November 23, 2020

SUBJECT: Requested Review and Analysis of a Fault Evaluation Report and Related Data for the Properties at 1751 and 1749 Malcolm Avenue, and 1772 Glendon Avenue, Los Angeles California

Wilson Geosciences Inc. (WGI) has conducted the requested review and analysis of the following reports:

FIGURE 2 – Summary of 1749/1751 Malcolm Avenue and 1772 Glendon Avenue Fault Information Based on AES Reports and Related Data

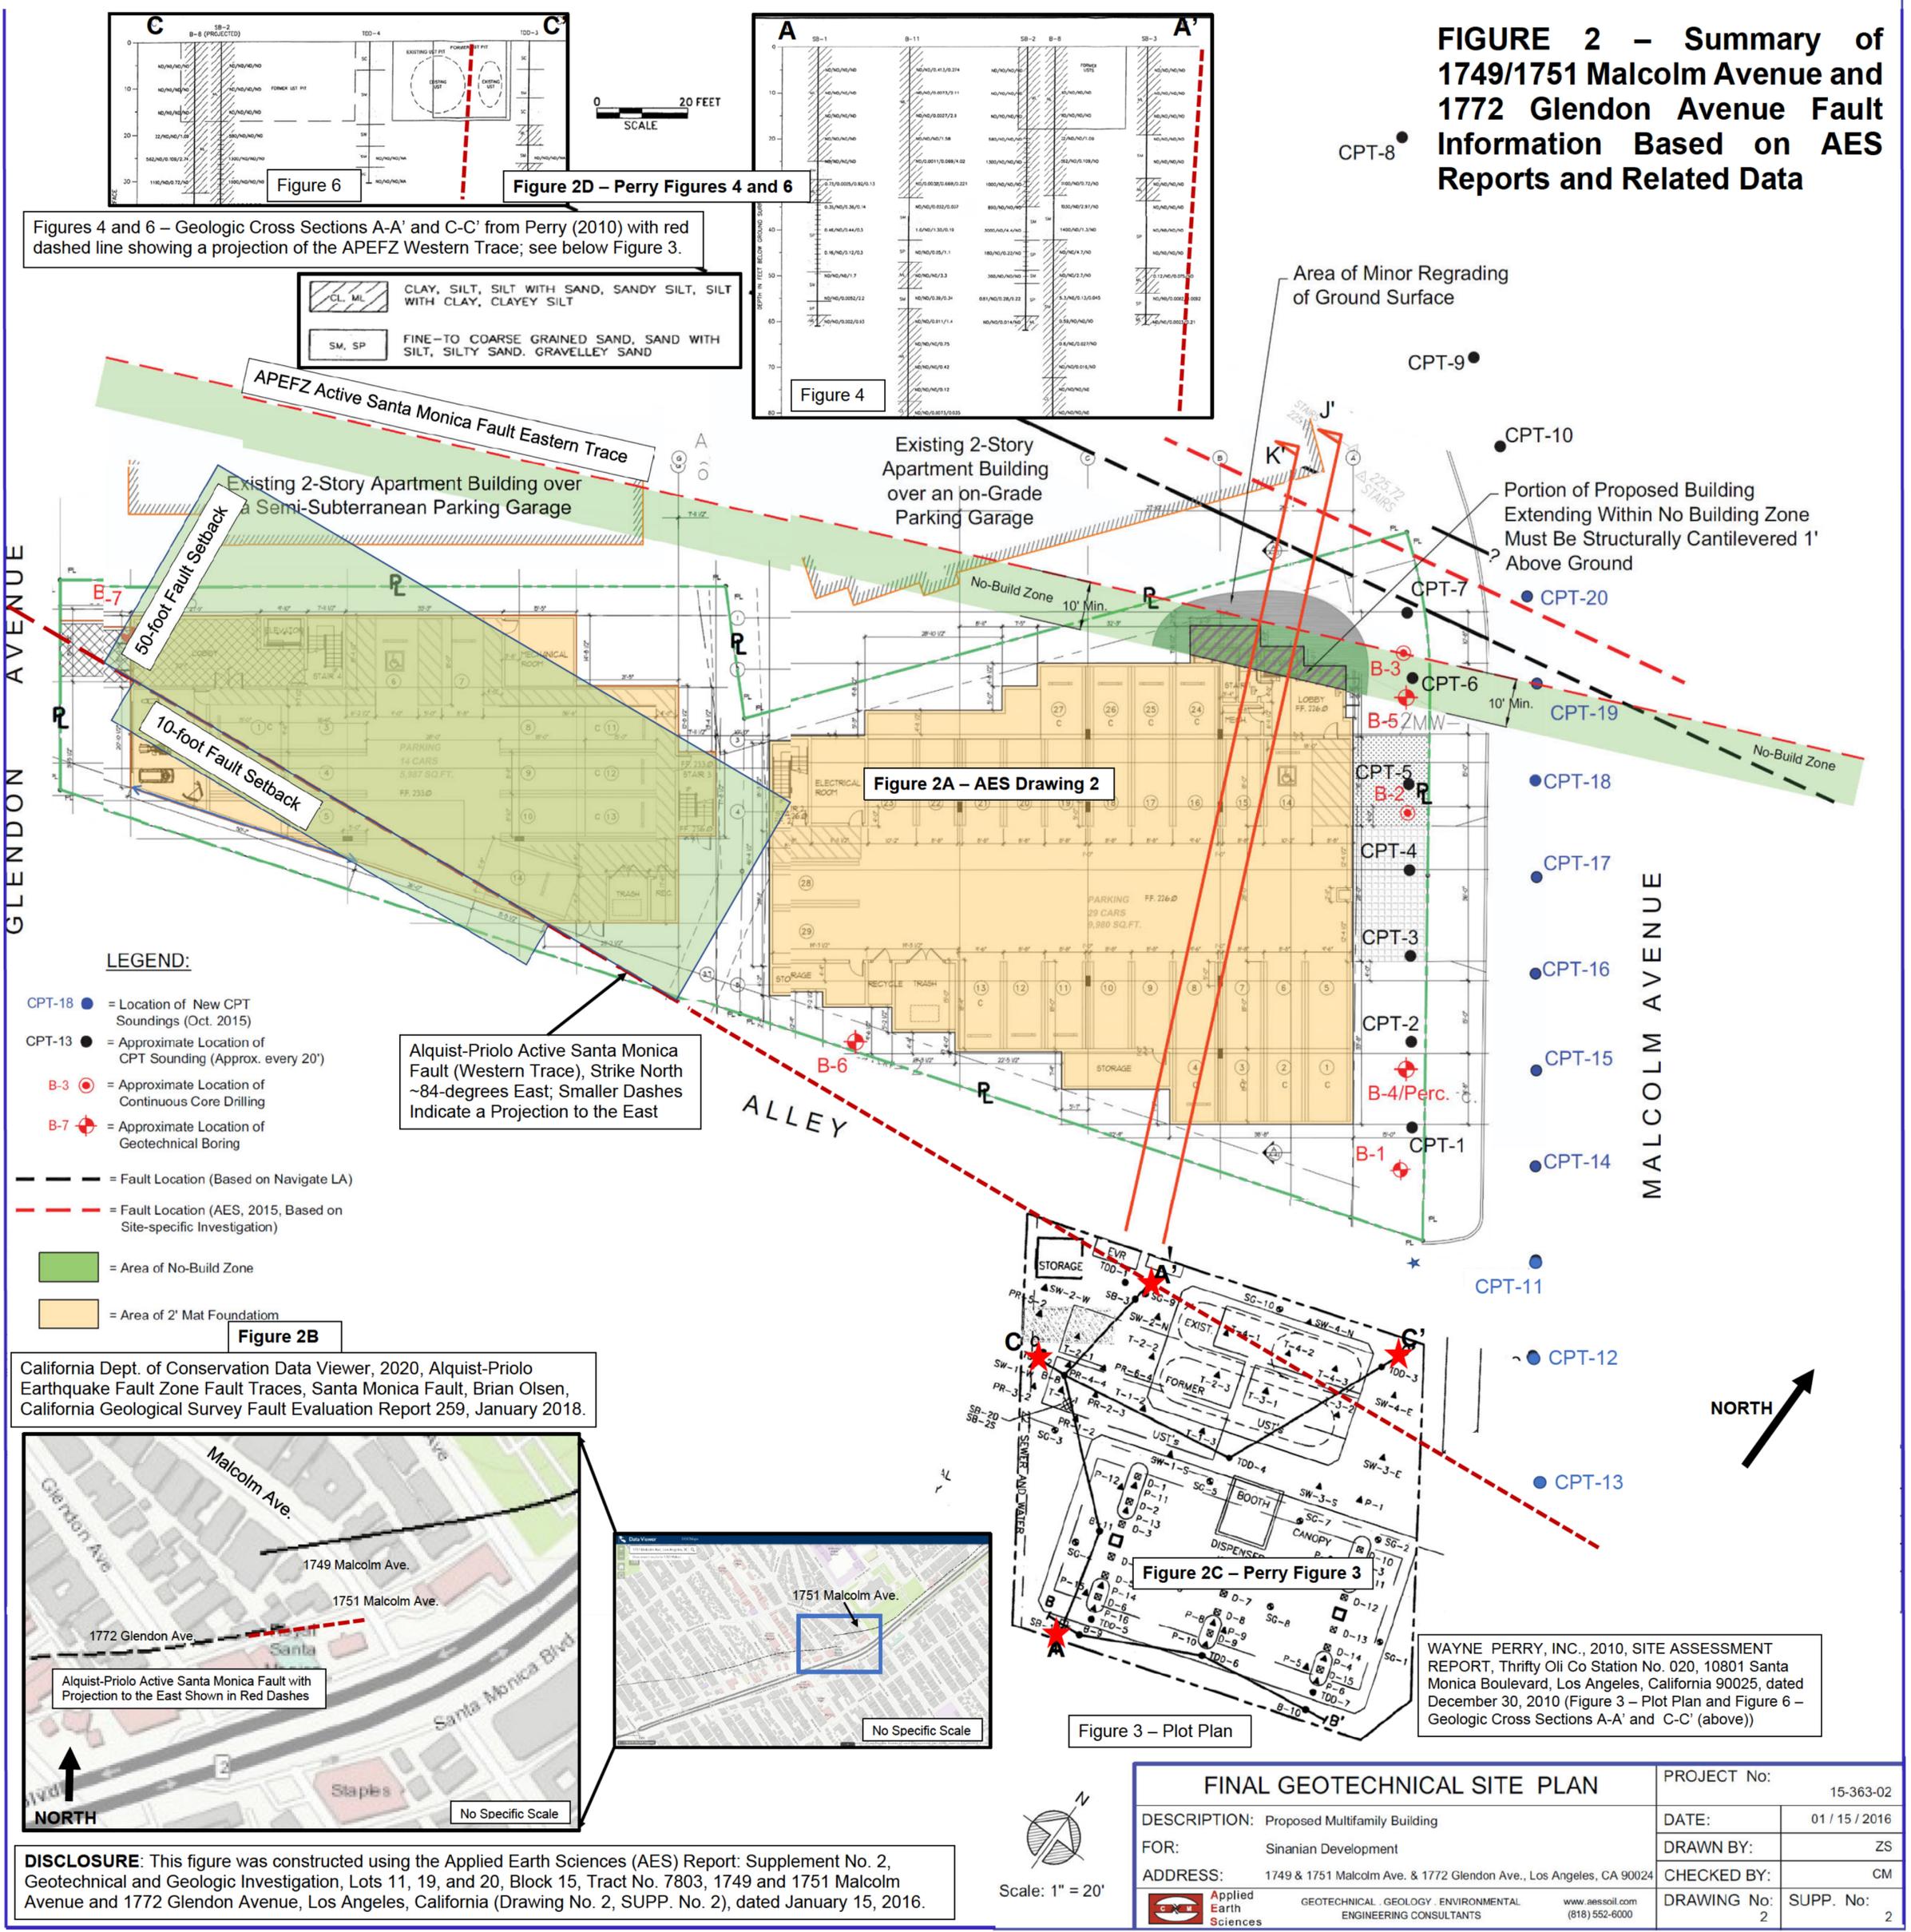
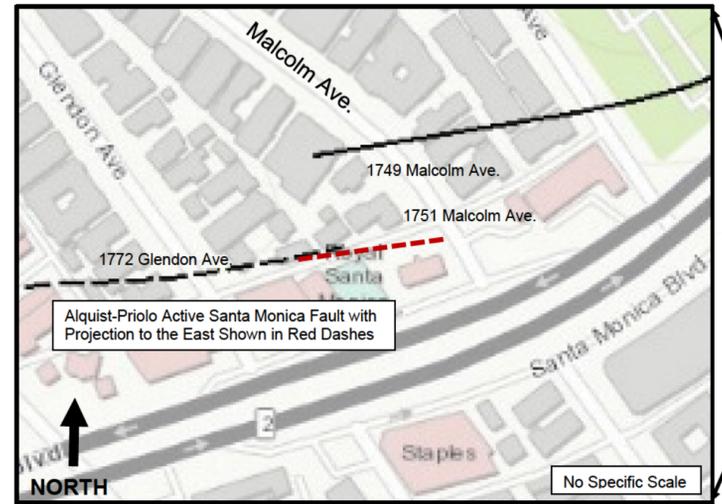
Eastern Fault Trace - FER-259 shows two APEFZ fault traces at the Site, each crossing portions of the proposed development area (Figure 2B). AES focused their studies only on the eastern fault trace entering the Malcolm Project s from the east and crossing a portion of the northcentral section of the Site. The AES reports

Western Fault Trace - FER-259 shows an APEFZ fault trace (Figure 2B) entering the Glendon Project site about midway along the western Site boundary and trending approximately north 84-degrees west. This fault crosses the proposed Glendon Project site development then exits the south side of the Glendon Project site at roughly the boundary driveway between 1751 Malcolm and 1772 Glendon at the alley. Had AES performed analysis of historic aerial photographs and topographic maps as was done for FER-259 and mandated by City of Los Angeles P/BC 2014-129 and 2020-129, they would likely have found this western fault trace entering the Site from the west and crossing a portion of the central section of the Glendon Project Site. No investigation was conducted along Glendon Avenue, along the driveway between the two lots, in the open space between the houses on the lot, or along the adjacent alley on the south similar to the investigation along Malcolm Avenue. Therefore, this western APEFZ trace was not determined to be present or absent as required within a known APEFZ before the final permit was approved.

The AES field investigations (CPTs) along the east side of the Site (Figure 2A) extended quite far to the south (CPT-13) adjacent to the ARCO Station at the northwest corner of Malcolm Avenue and Santa Monica Boulevard. The ARCO site was studied¹⁶ as the Thrifty Oil site, and numerous borings were drilled and logged (Figure 2C). The AES report references the Perry report, but did not provide the boring logs and cross-sections. We obtained these through other sources. Perry cross-section A-A' (Figure 2C and 2D) shows what appears to be a south-to-north lithologic change when compared to AES's CPT-13 through CPT-18. The Perry cross-section A-A' stratigraphic section of clay, silt, silt with sand, sandy silt, silt with clay, and clayey silt seems to correspond to the sag pond deposits of AES north of CPT-18. A projection of the western APEFZ trace (Figure 2A), northwest to southeast from Glendon Avenue, passes just north of Perry

cross-section A-A' (their borings SB-3, B-8, and SB-2, B-11, and SB-1) and if continued to the southeast would pass south of CPT-13 into an area not studied by AES. This suggests the presence of the active western fault trace extending to the vicinity of Perry cross-section A-A' before likely stepping left to the eastern trace, with an uplifted fault block in between.

Figure 2D – Perry Figures 4 and 6

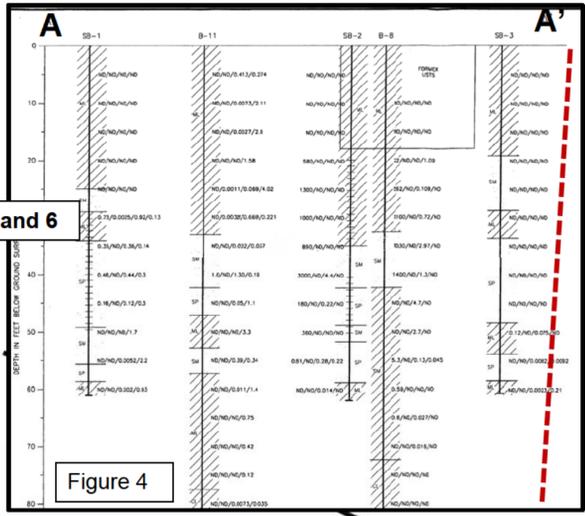
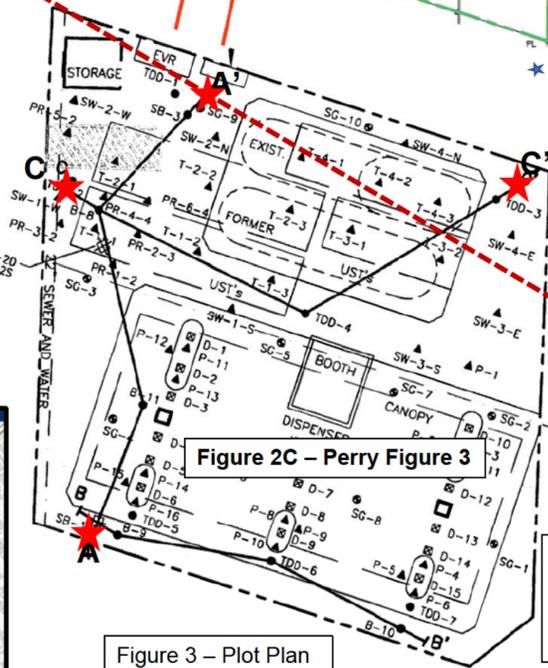
The western active fault trace, per FER-259, traverses the 1772 Glendon property and the central portion of the proposed building. Analysis for this report of the current ARCO service station site's 2011 environmental assessment report by Wayne Perry²¹ (their cross-section A-A'; our Figure 2D) suggests this western fault trace may cross into the ARCO site before left-stepping north to the eastern active fault trace. Geologic materials south of the western fault trace along Perry's A-A' are very similar to the sag pond deposits north of the eastern fault trace suggesting an uplifted fault block between the two active fault traces. A 2015 study²² of the magnitude 7.3 Landers earthquake indicates that such locations are where "the magnitude and width of distributed deformation are largest in stepovers, bends, and at the southern termination of the surface rupture". The Site is such a location where such ground deformation, not specifically mentioned by AES, could occur.
